**Applicants' response to Councils Urban Design Referral Response dated 25/10/2021**

**Proposed development (Section 4.55 Application)**

**68A Queenscliff Road, Queenscliff NSW 2096**

Diagram 1.

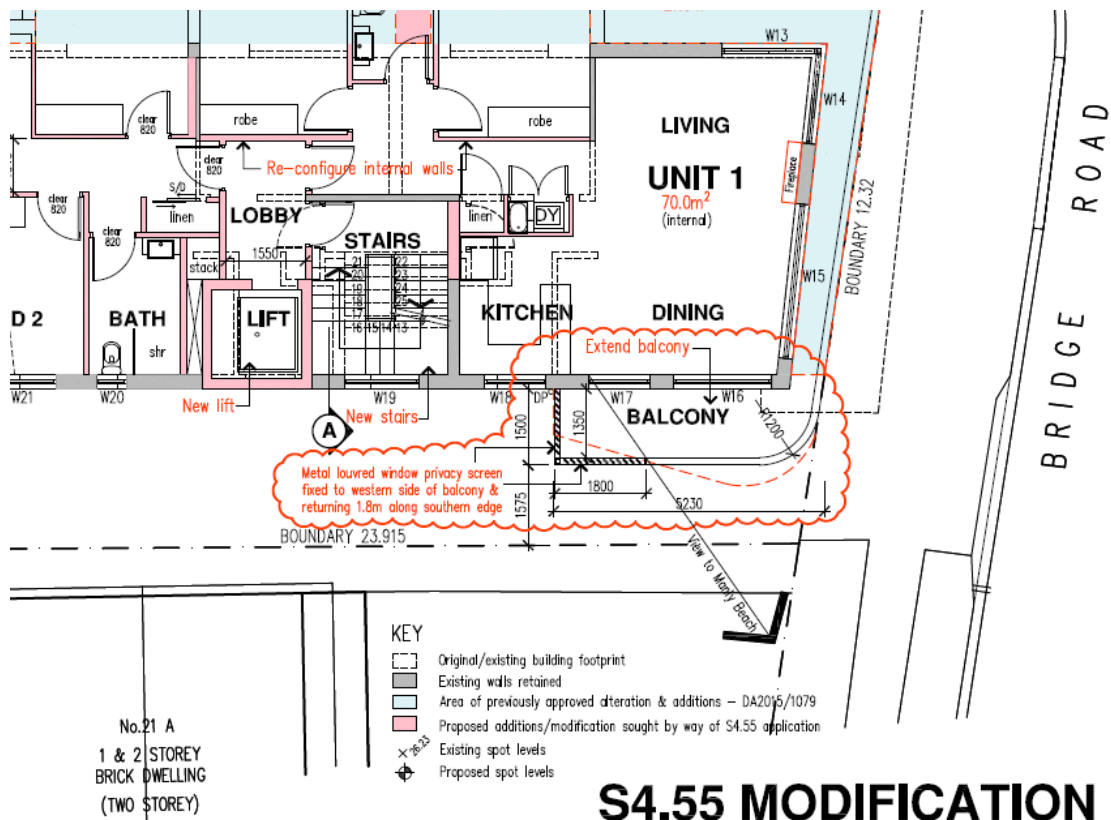
- 1. The new balconies proposed facing south will present overlooking privacy and noise nuisance issues to the adjacent property to the south.*
- 2. Similarly, the proposed south facing glazed acoustic barrier to the outdoor seating area should be opaque glazing up to a height of 1.2m from the floor to reduce overlooking privacy issue to the southern neighbour.*
- 3. The applicant should address the possible amenity nuisance issues (especially light and noise) from the extended outdoor seating area which is proposed to double in size allowing more people to gather along the southern boundary.*

It is acknowledged that the current building does not have balconies along its' southern façade, and therefore it could be argued that some additional overlooking/privacy and noise concerns could be experienced to the adjoining property to the south with the inclusion of such balconies. Interestingly though no objections have been received from any adjoining owners, and in particular, the owner of No.21A Bridge Road.

Notwithstanding we include compromise redesign of the balcony in a manner that further mitigates detrimental effects upon No.21A Bridge Road and still offers improved amenity to the future occupants of No.68A Queenscliff Road.

Refer Diagram 1 on the following page.

It is hoped that this compromise can be reassessed, be considered favourably and conditioned accordingly.

Diagram 2.

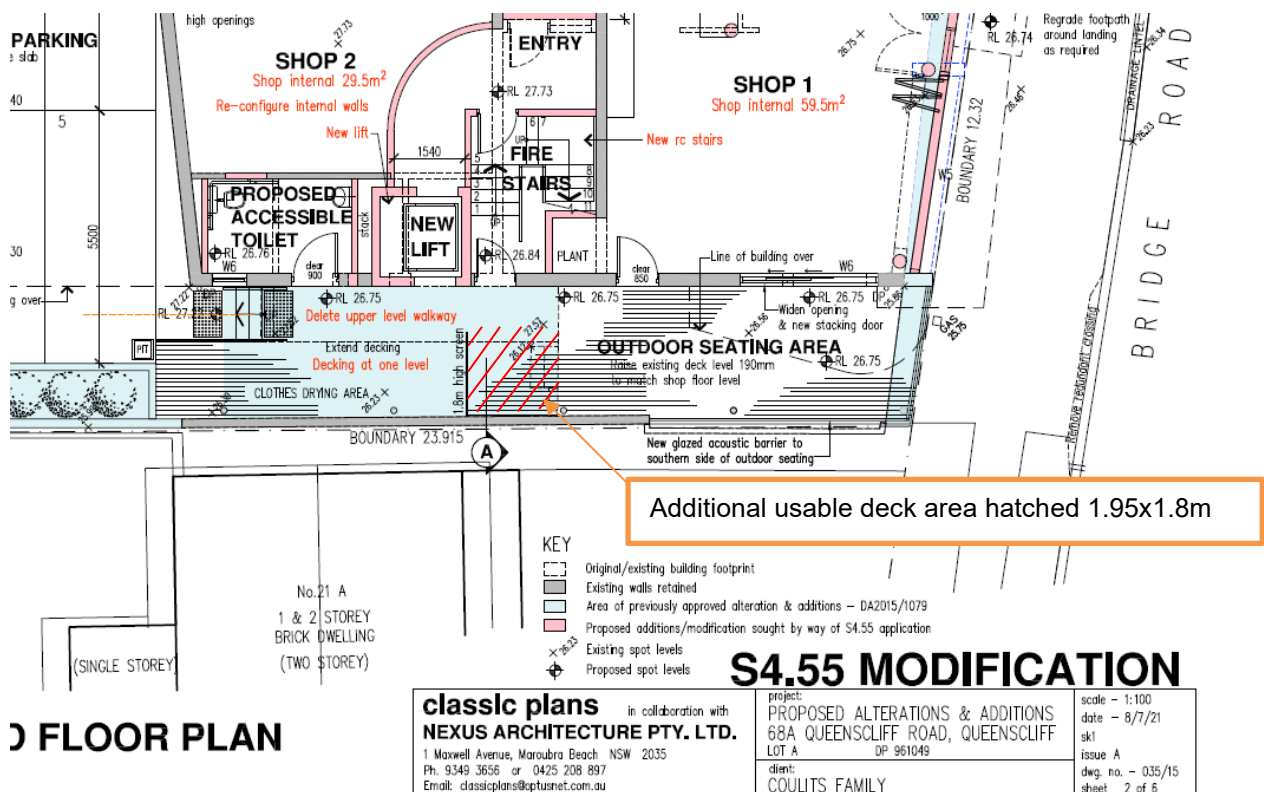
The suggestion that the deck area is "to double in size and allow more people to gather along the southern boundary" is not correct.

The hatched area in Diagram 2 above depicts the cafe decks' additional usable area, being only 3.5sqm. This additional area will be located behind the existing masonry block wall. A new screen will divide café area from the clothes drying area limits the cafés deck usage.

Noise and light spill issue are not expected to exceed that of the previous approval with the additional 3.5sqm of deck area. It should be noted also that there are no windows to the northern wall of No.21A Bridge Road.
